**AGENDA
PLANNING & ZONING COMMISSION
THURSDAY, May 10, 2018
7:00 P.M. TOWN HALL**

TITLE: Red Hill Lofts Request for Special Review for Site Plan and Architectural Review
(Lot 12B Kay PUD)

RE: Red Hill Lofts Kay PUD Amendment Special Review for Site Plan and Architecture Design
Application—Lot 12B, Kay PUD, Carbondale Colorado

planting plan
L200
© copyright bluegreen

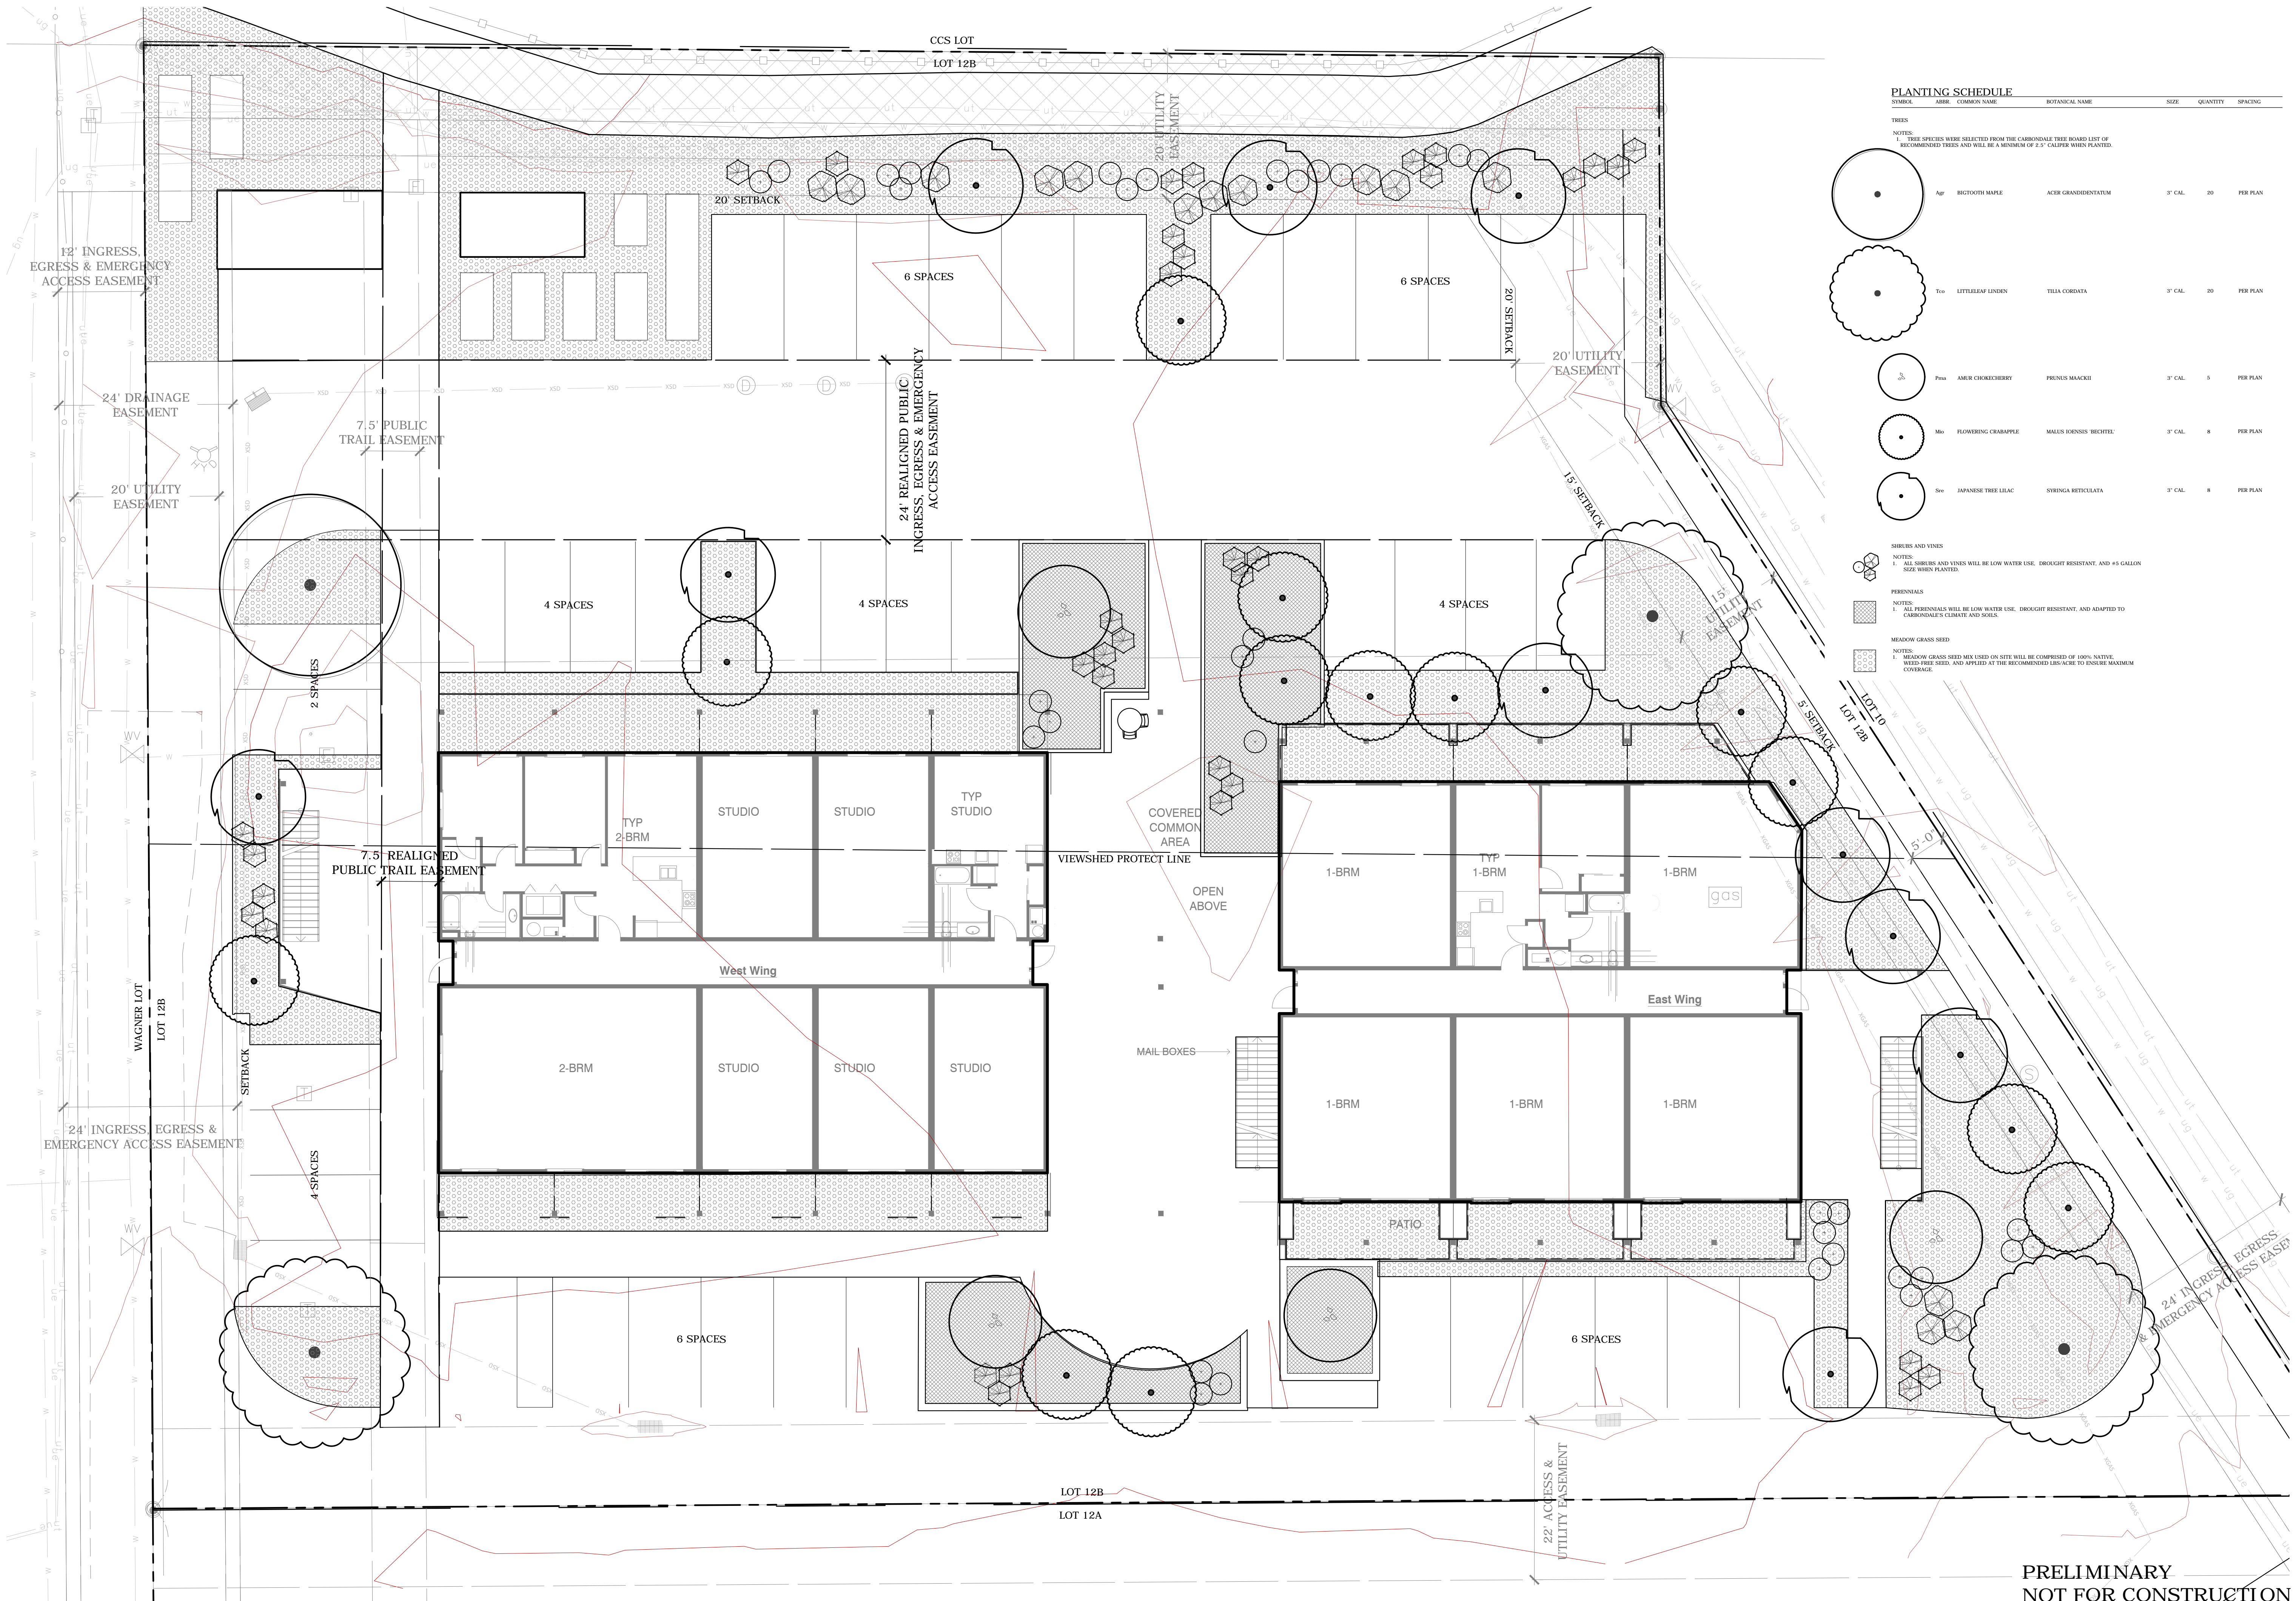
The applicant has provided a landscaping plan that is generally in conformance with the PUD requirements. An item to note is that the PUD requires sixty trees to be planted on site. The applicant is proposing to plant 31 trees on site and that the remainder be planted elsewhere in the PUD or on the Community School property. Staff is supportive of the proposal but will need to have verification that the trees have been planted off site. This has been made a condition of approval.

The applicant has indicated that they will plant 31 trees on site and the remainder of trees, 29 will be planted in other locations to be determined. This has been made a condition of approval.

The Kay PUD requires that two trees be planted for each residence if additional density is proposed. Sixty trees are required under this provision, and 31 trees are proposed in the planting design. We propose to plant the remaining required trees elsewhere in the PUD (where irrigation from adjacent properties is available) or at the Carbondale Community School (if approved). If off-site planting is not possible, we request that the requirement be satisfied with the proposed 31 trees.

Response: We propose to plant 31 trees on site. The remaining trees will be planted elsewhere in the PUD (where irrigation from adjacent properties is available) or at the Carbondale Community School (if approved). If the remaining trees are unable to be planted in these areas, we request that the proposed trees satisfy this requirement. Note: This requirement is specific to the Kay PUD and is no longer required in the Town's code.
